Land at Bird in Eye Farm
South of Bird in Eye Hill
Uckfield

TRANSPORT ASSESSMENT SECOND ADDENDUM

Planning Reference: WD/2021/2198/MAO

MT/5330/TA2A.2
September 2022

DRAWN BY ARM/JCB	DESIGN BY MT	CHK BY MT
DATE 06/04/21	DRAWING No. 5330 / 016	REV No. F
SCALE 1:250 @ A1

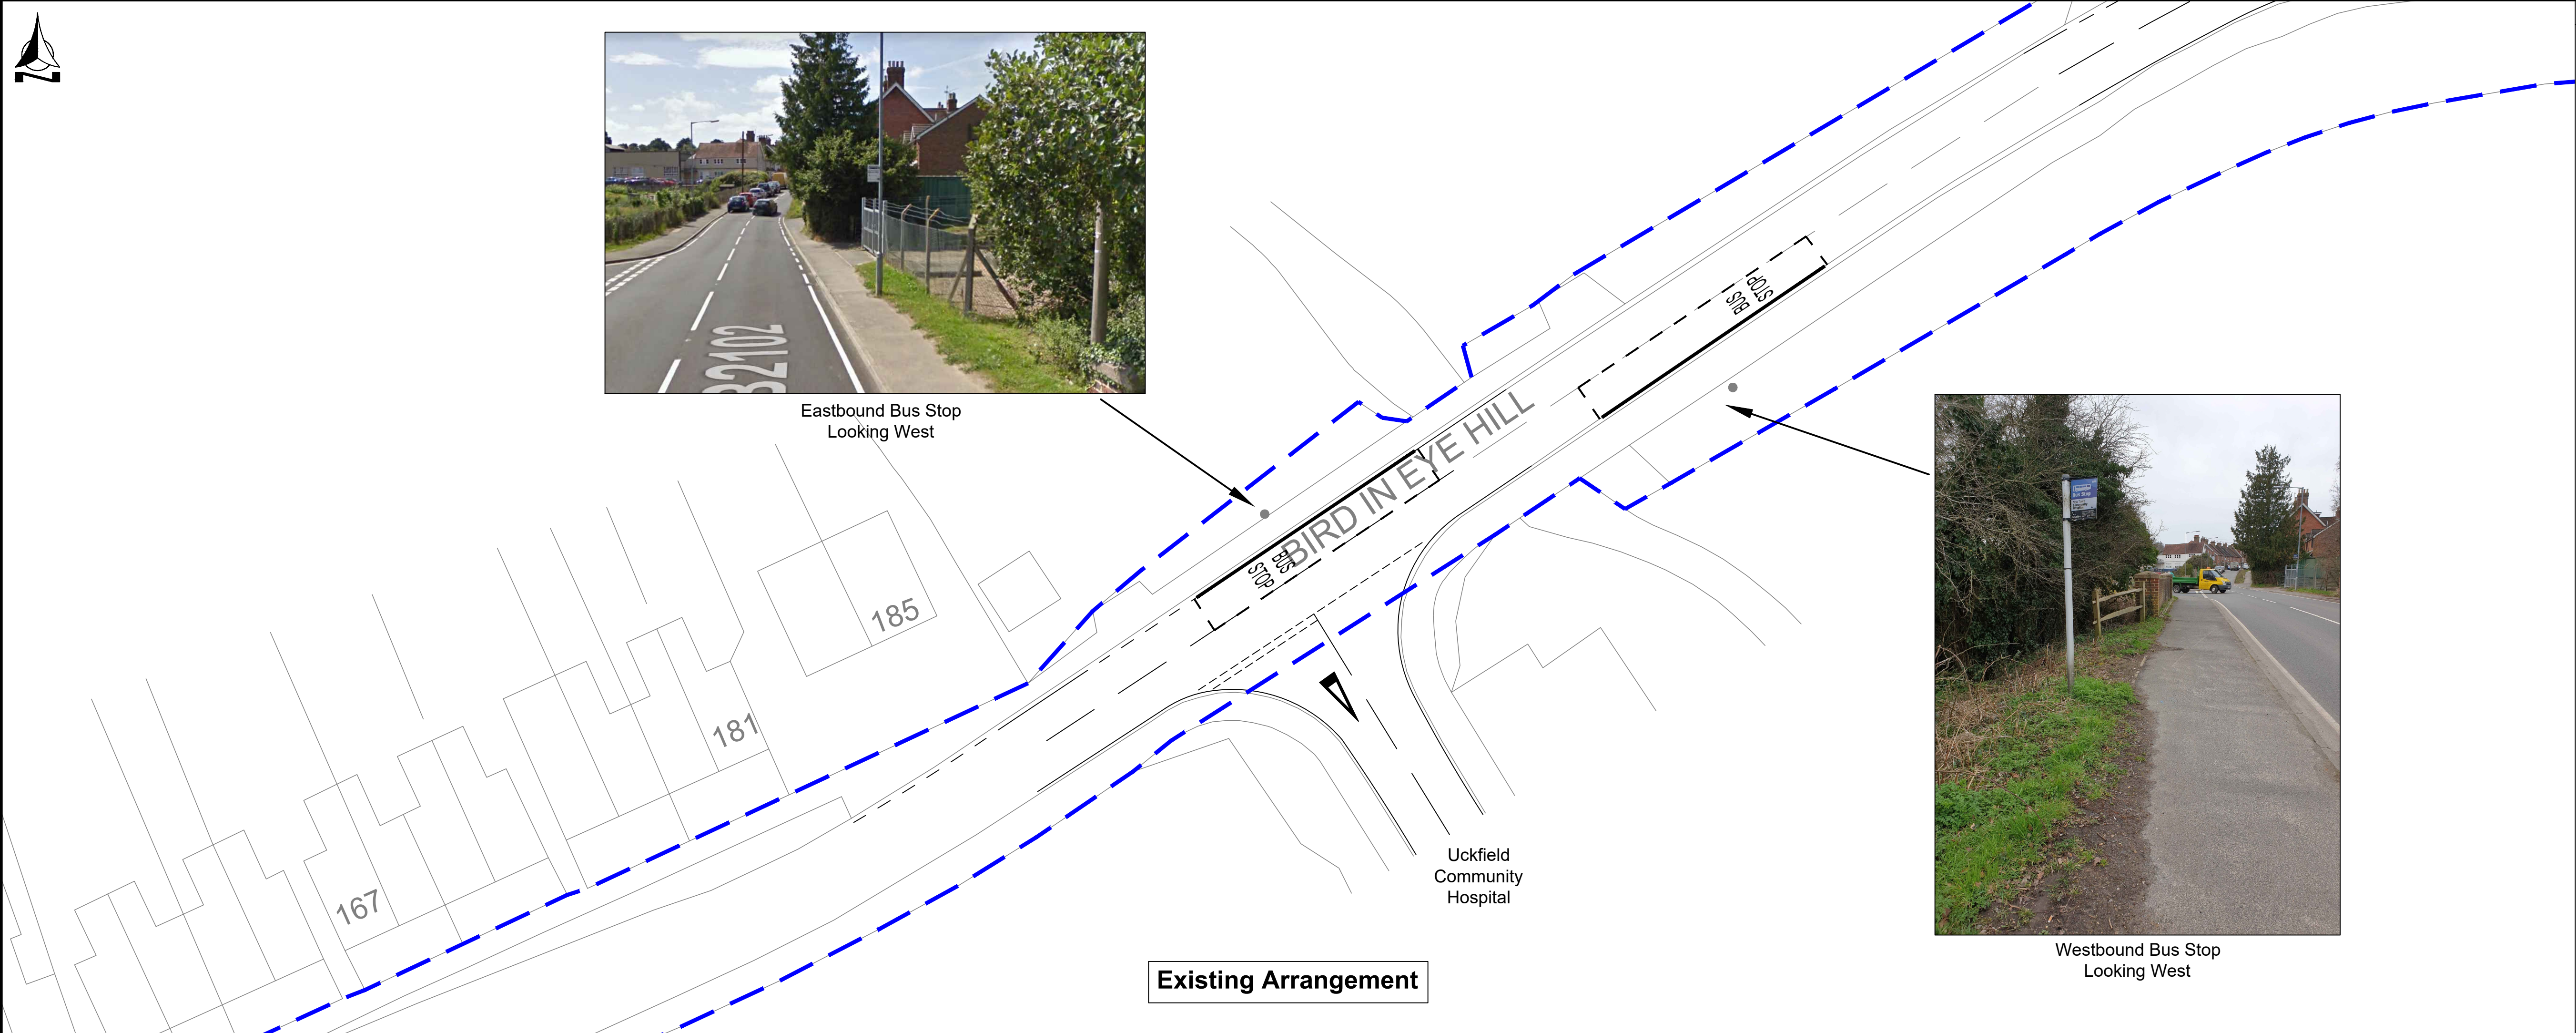
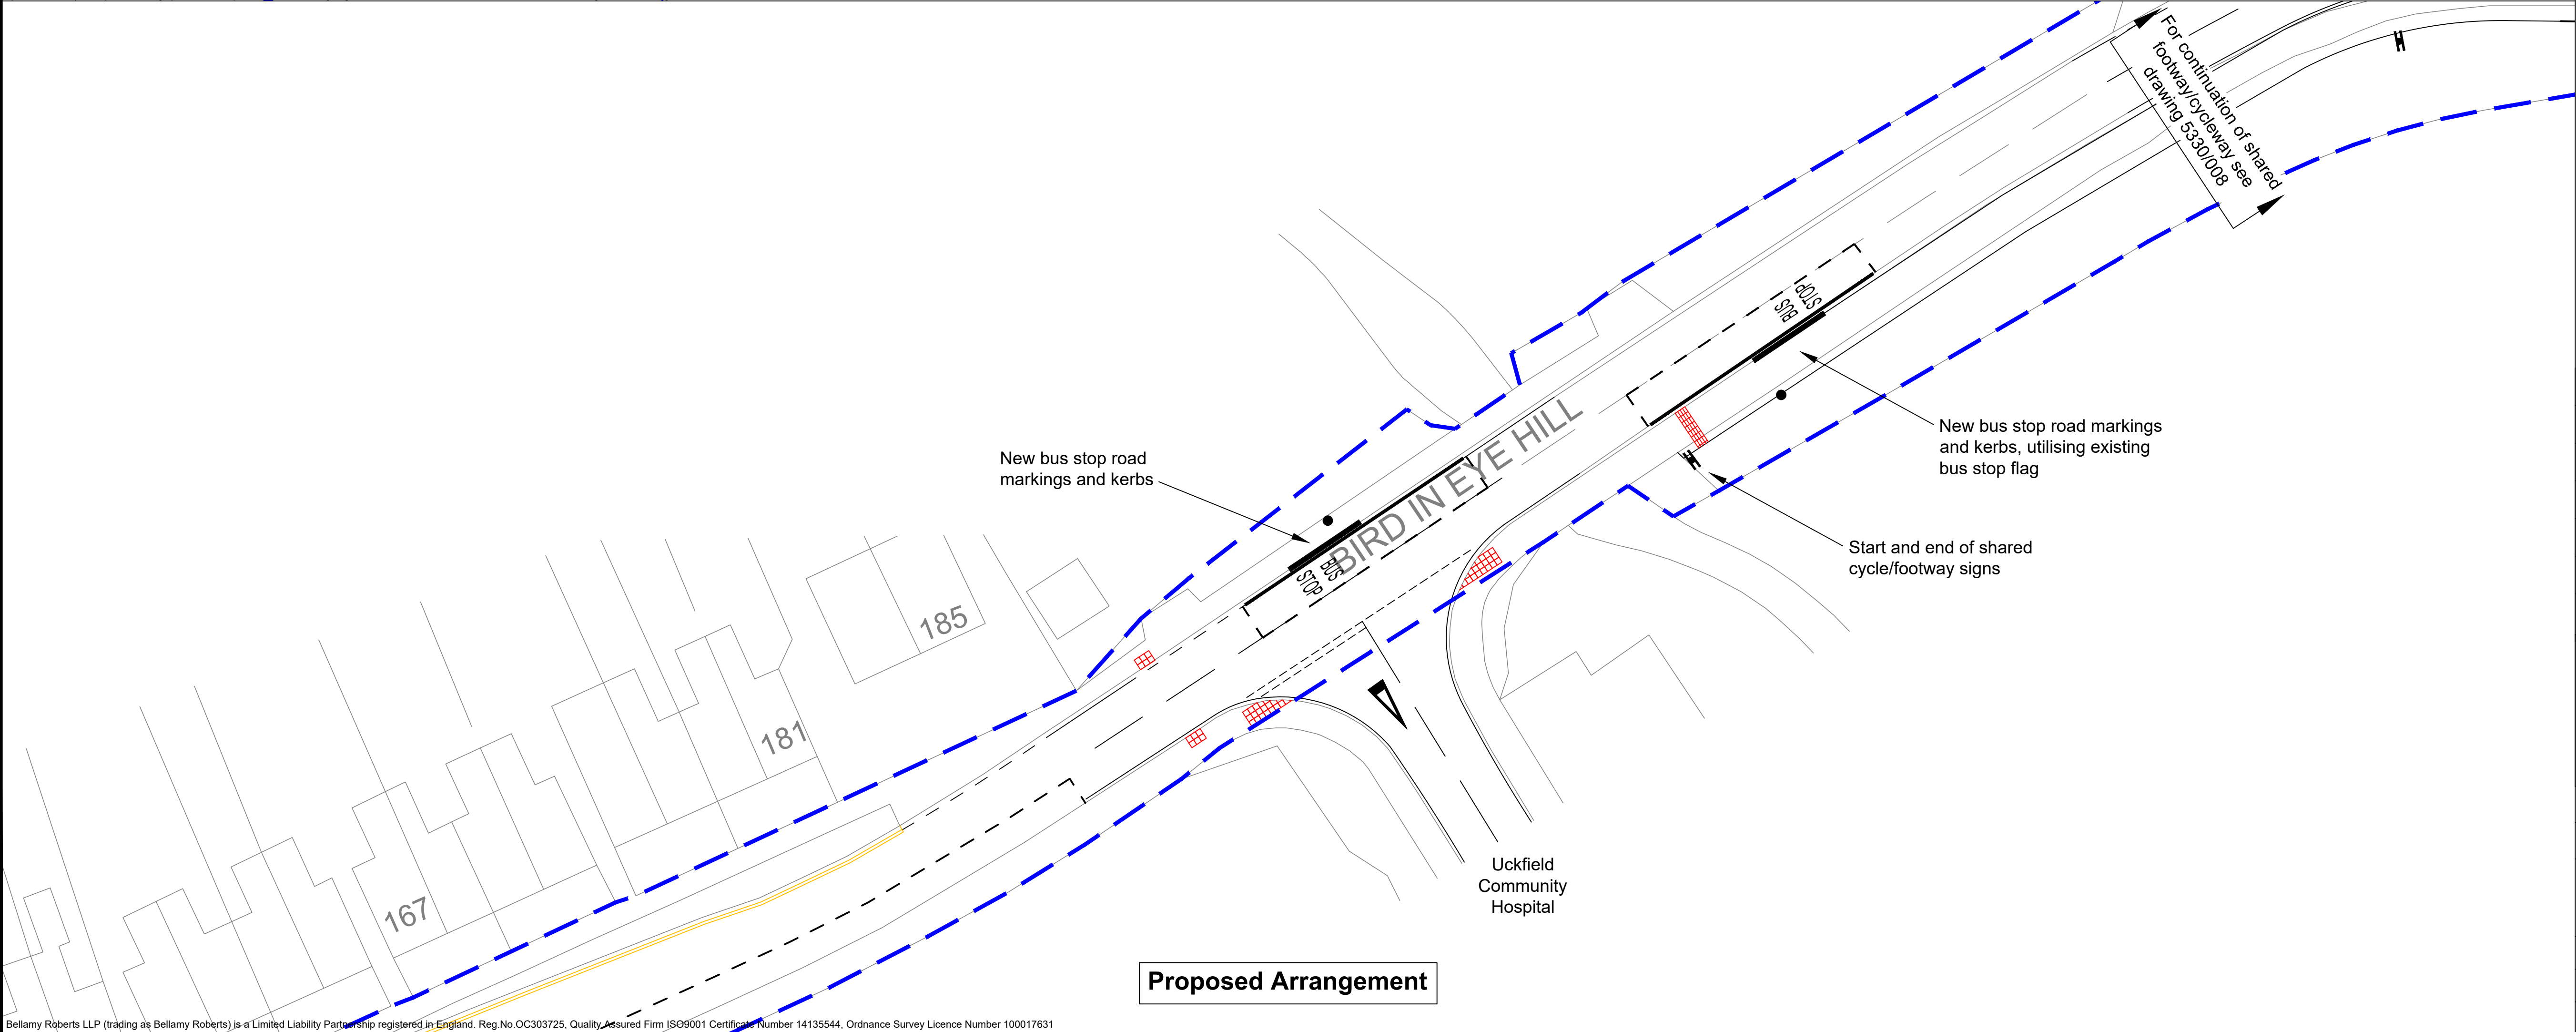
Splitter islands on Bird in Eye Hill: the proposed tapers are not in accordance with CD123, and revisions have been made in dwgs 5330/008E, 020C and 016E. I do not have access to these drawings as they are not provided as part of the TA addendum or application submission.

2.41 Drawings 5330/008 (**Appendix 8**) and 016 (**Appendix 9**) have been amended following comments received from the Safety Auditor and from the CHA, particularly regarding the previously proposed improvements to the bus stops at the Hospital access. The CHA has recently Technically Approved improvements to these bus stops as part of the nearby Mallard Drive development. This drawing has been supplied by the CHA and our proposed improvements have been amended to reflect these works.
